CROSS SECTIONS

REVISED NDC02	STATE VA.	ROUTE 621	STATE PROJECT 6234-076-266, C-501, RW-201	SHEET NO. X178
------------------	--------------	--------------	--	-------------------

Ramp 1A

REVISED NDC02	STATE VA.	ROUTE 234	STATE PROJECT 6234-076-266, C-501, RW-201	SHEET NO. X362
------------------	--------------	--------------	--	-------------------

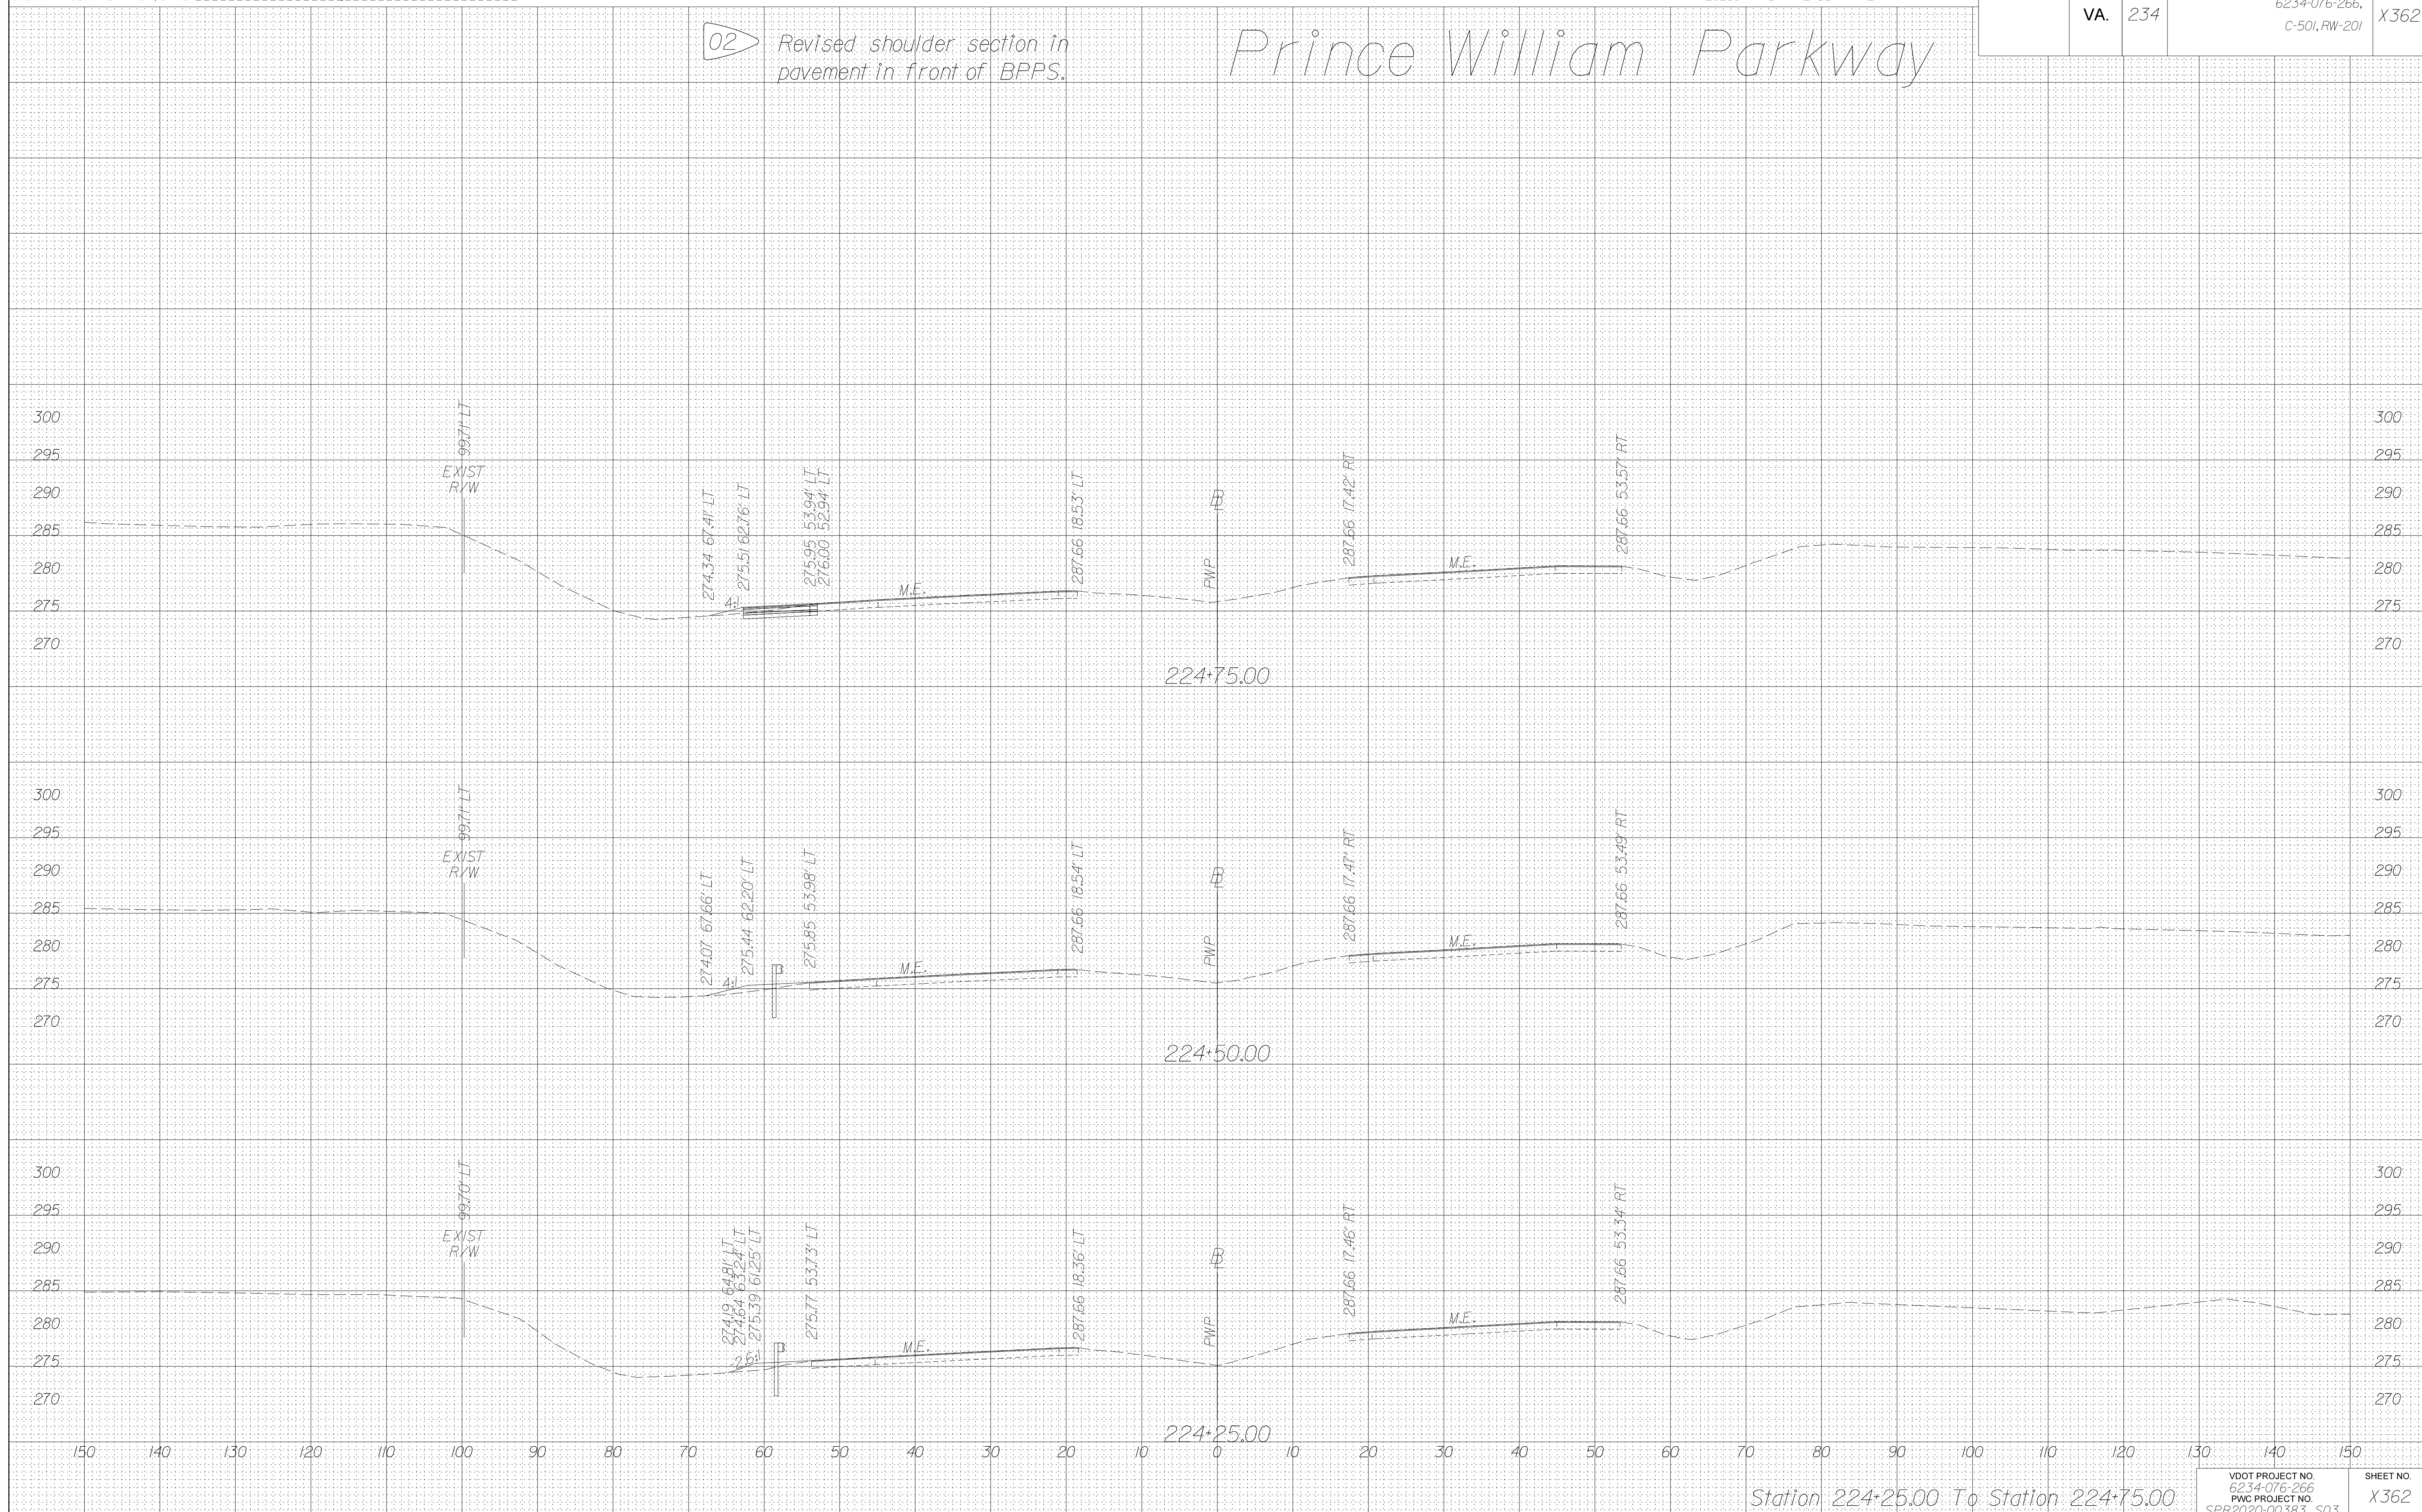
02 Revised shoulder section in pavement in front of BPPS.
